JWA MARK-UP
14 OCT 2011
STUDIO STRATEGY

Project: Faculty of Architecture
Building and Planning

Title: GENERAL ARRANGEMENT
LEVEL 01 FLOOR PLAN - LO

Project No.	0915	Scale	1:100 @ A0 1:200 @ A1
Drawing No.	AR1002	Revision	01

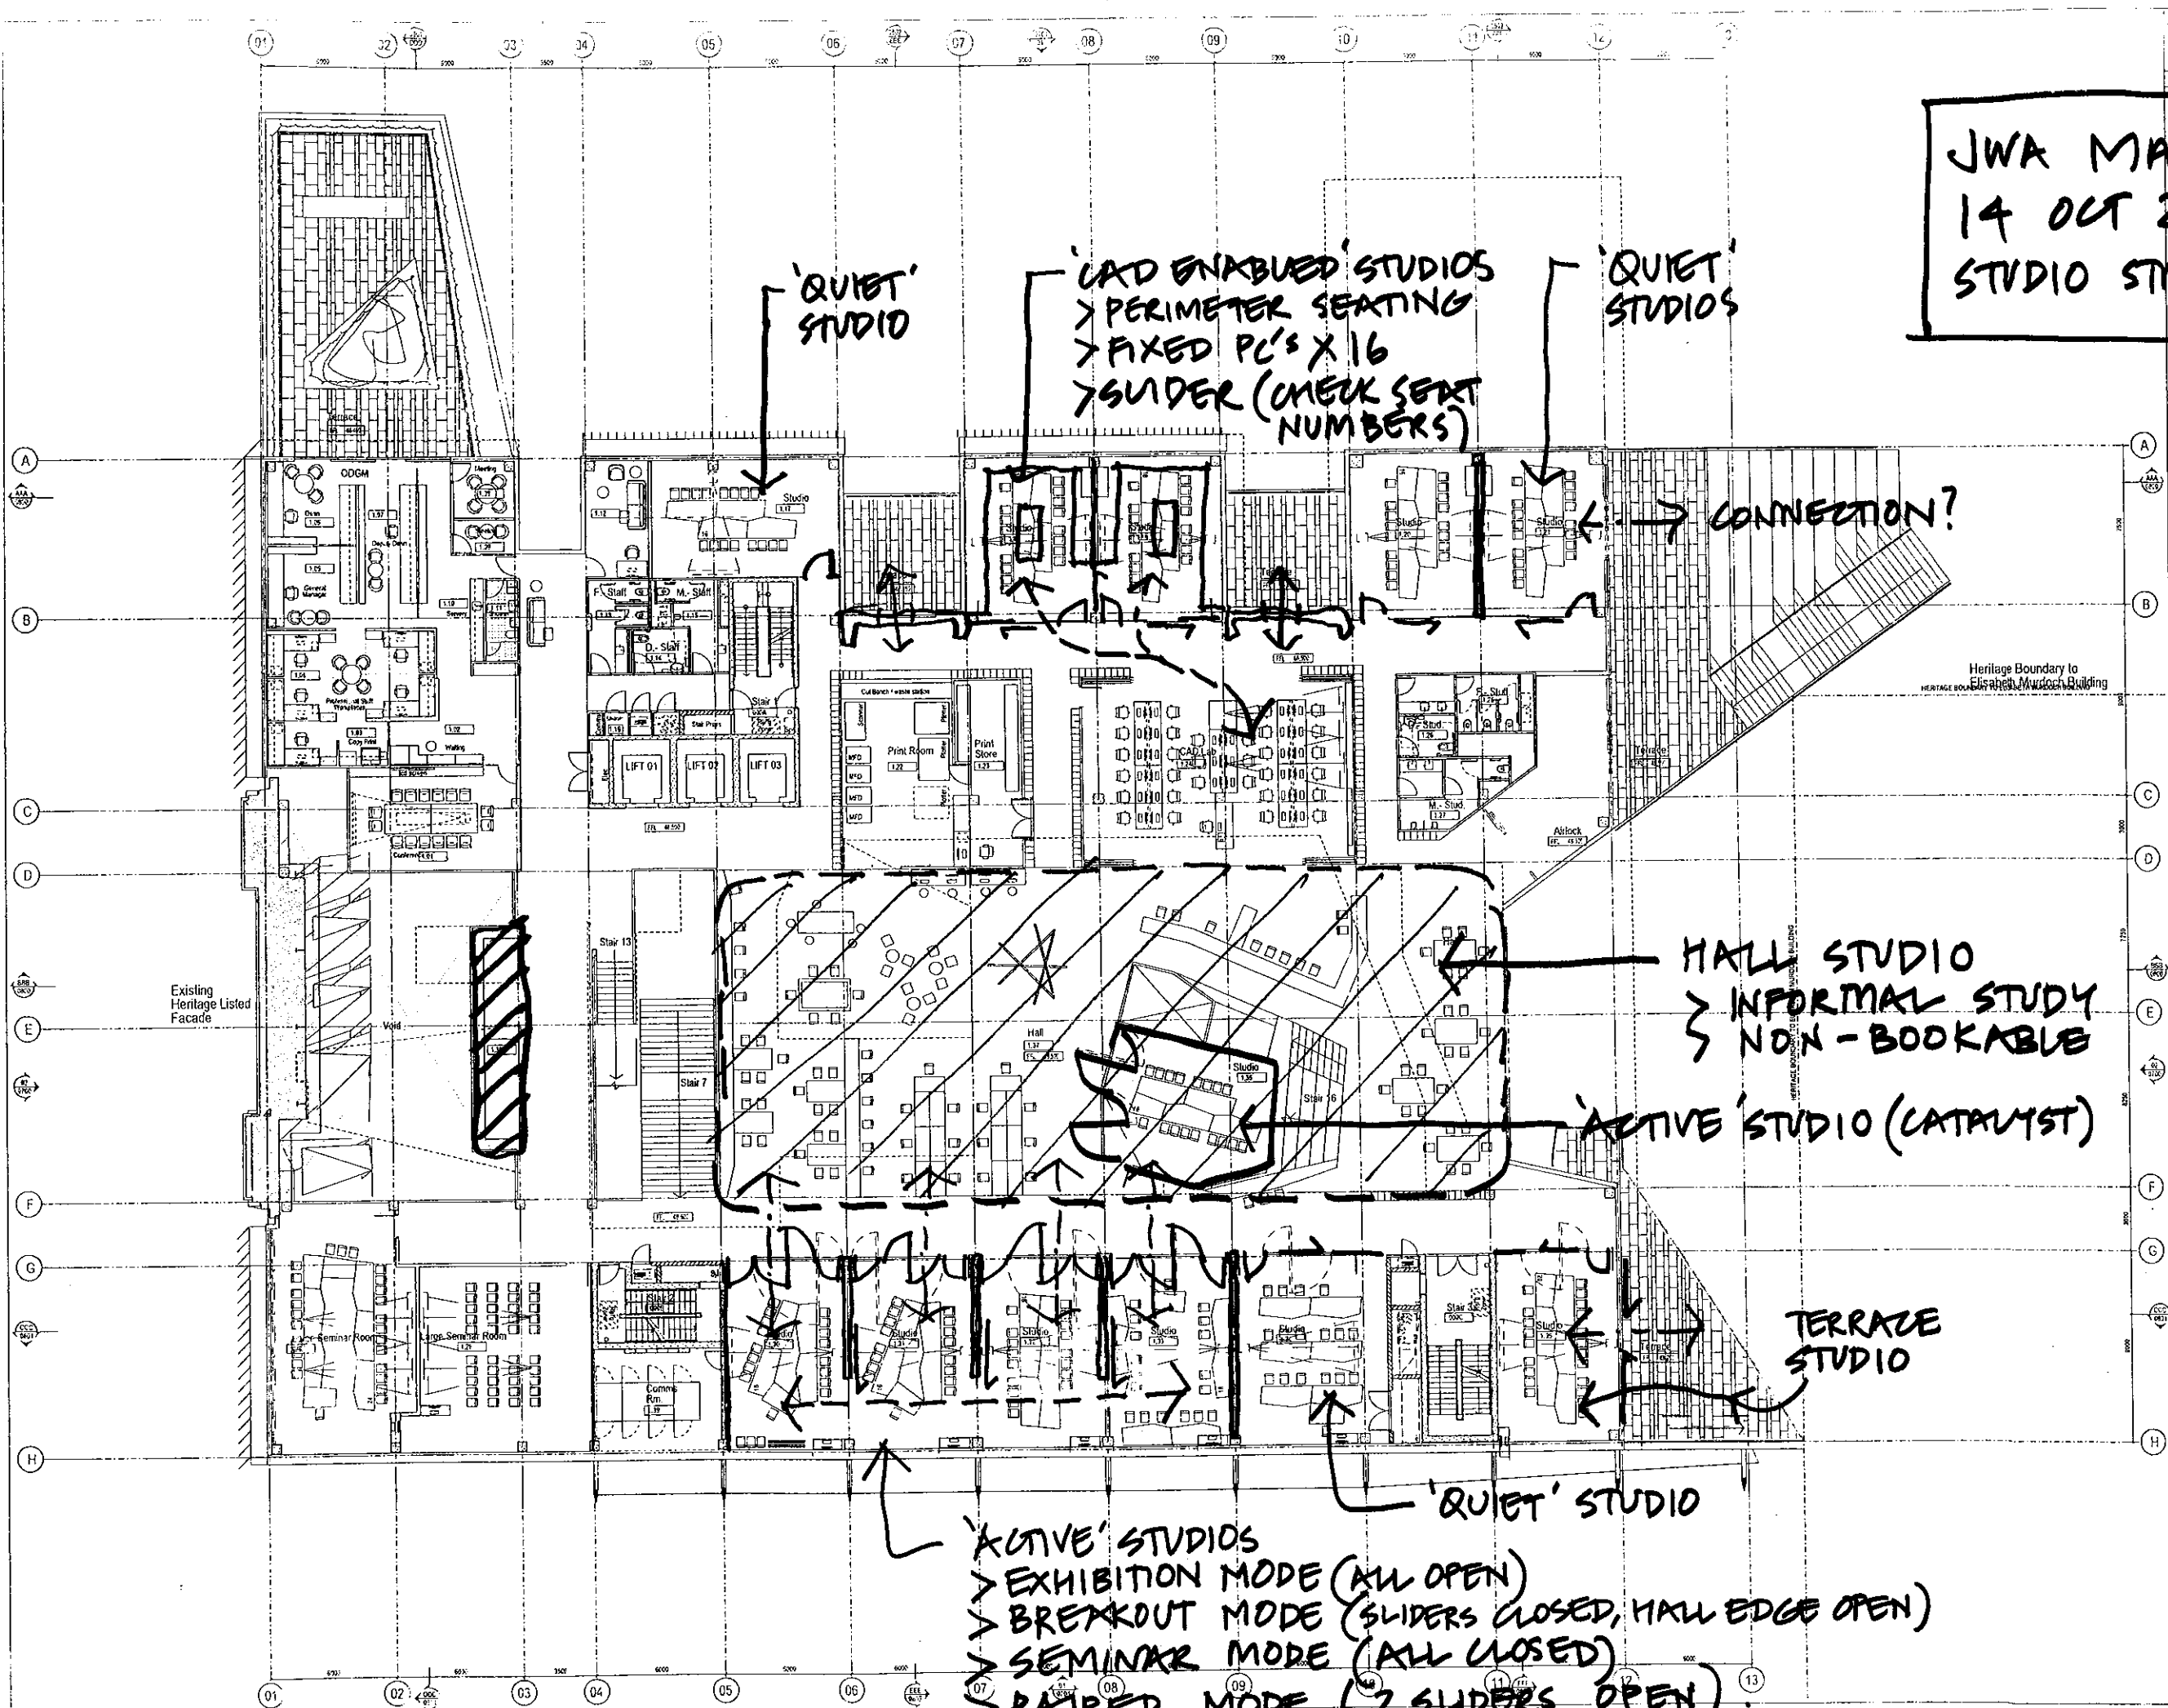
'CAD ENABLED' STUDIOS
> PERIMETER SEATING
> FIXED PC'S X 16
> SLIDER (CHECK SEAT NUMBERS)

CONNECTION?

HALL STUDIO
> INFORMAL STUDY
> NON-BOOKABLE

'ACTIVE' STUDIOS
> EXHIBITION MODE (ALL OPEN)
> BREAKOUT MODE (SLIDERS CLOSED, HALL EDGE OPEN)
> SEMINAR MODE (ALL CLOSED)
> PAIRED MODE (2 SLIDERS OPEN)

The GENERAL ARRANGEMENT
LEVEL 02 FLOOR PLAN - LUZ

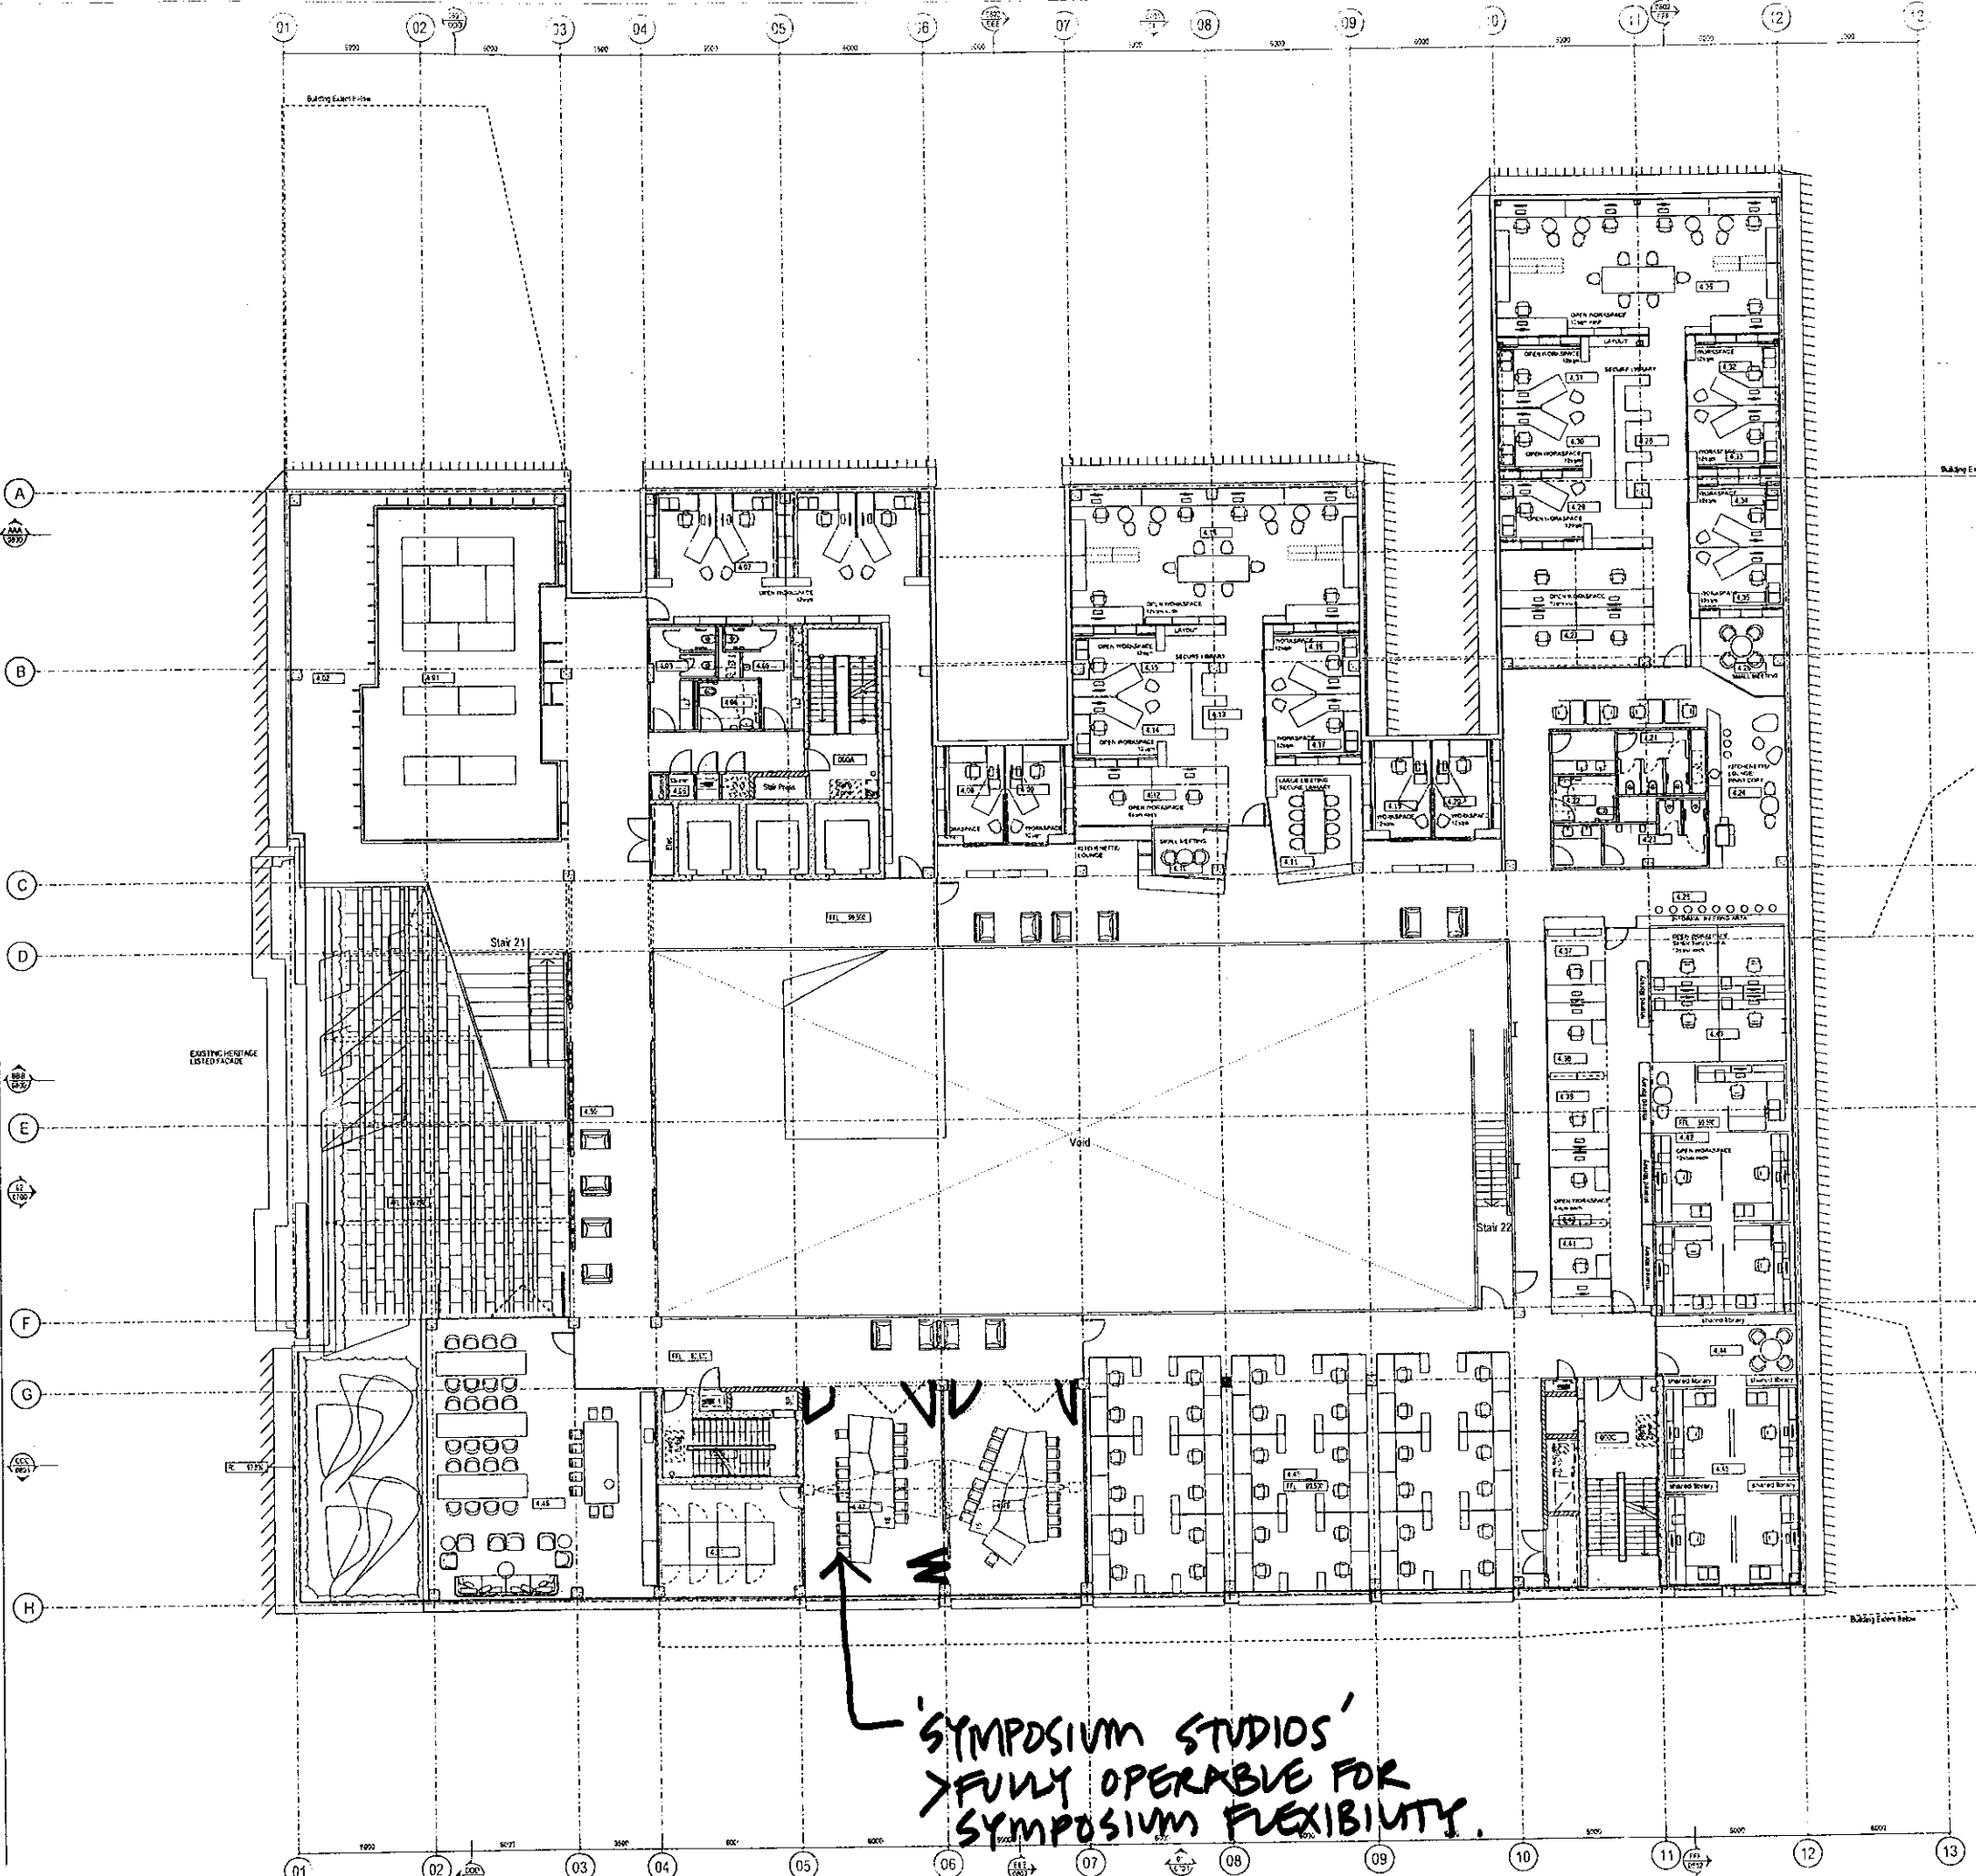
'QUIET' STUDIOS
> SEMINAR MODE
> PAIRED MODE
(OPERABLE WALL)

DOORS?
SUSPENDED STUDIO
(CATALYST)

HATCHED AREAS
NEED TO BE
FOR SMALL
GROUPS OF
STUDENTS,
SKY 3 TO 6,
TO DO COLLABORATIVE
WORK. FINAL
LOCATIONS TBC.

'CAD ENABLED' STUDIO
7 FIXED PC'S X 16
> SLIDER (CHECK SEAT NUMBERS)

'QUIET' STUDIOS.
> NO SLIDERS BETWEEN

The GENERAL ARRANGEMENT LEVEL 4 FLOOR PLAN - L04	
Project No. 0913	Scale: 1:500 @ A4 1:250 @ A3
Drawing No. AR1005	Revision: 01
Date: Nov 2011	Drawn: Co-Ord: Chk:
FILENAME: P:\0909\0913\1005\Architecture\Building\Production\CAD\Drawings\Level 4 L04.rvt	
PRELIMINARY ISSUE

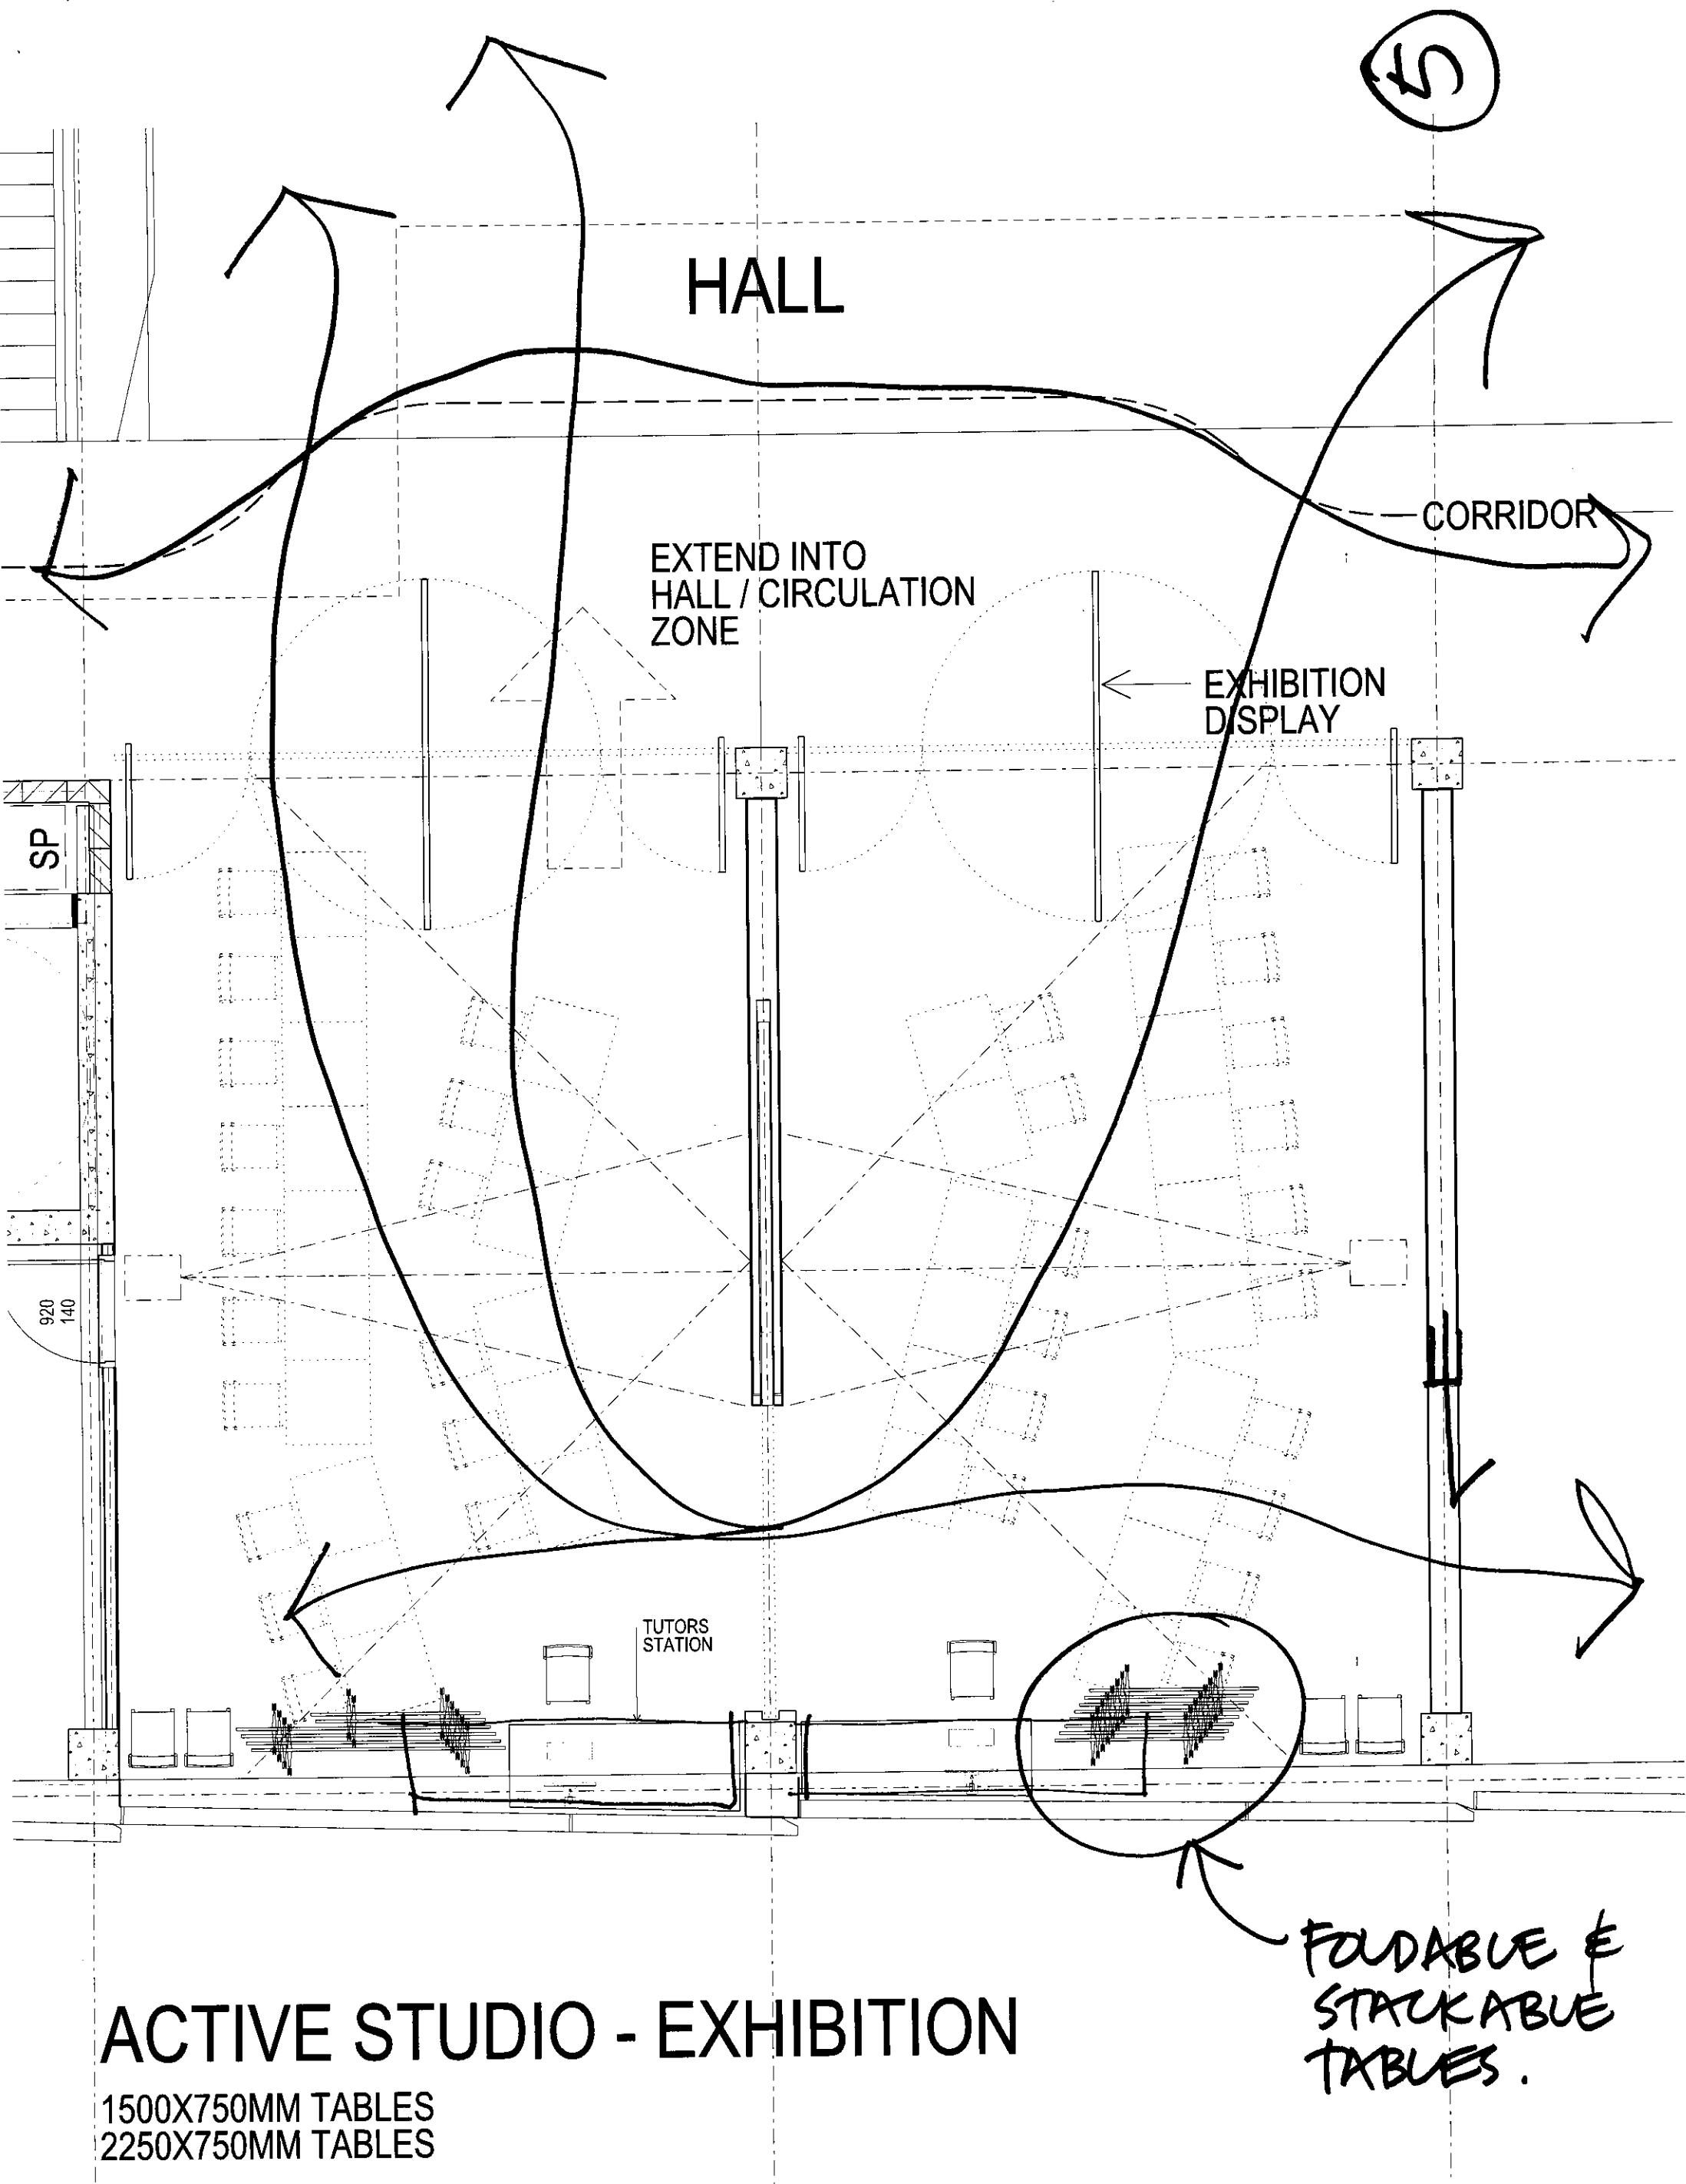
EXTEND INTO
HALL / CIRCULATION
ZONE

ACCESS
CONTROL
DOOR

EXHIBITION
DISPLAY
(PIN-UP)

COLLABORATIVE
LEARNING
LAYOUT
(GROUPS OF
4-6)

WRITABLE
GLASS
SURFACE

PINUP
SURFACE

PIN UP
SURFACE
ON DOOR
BOTH
SIDES.
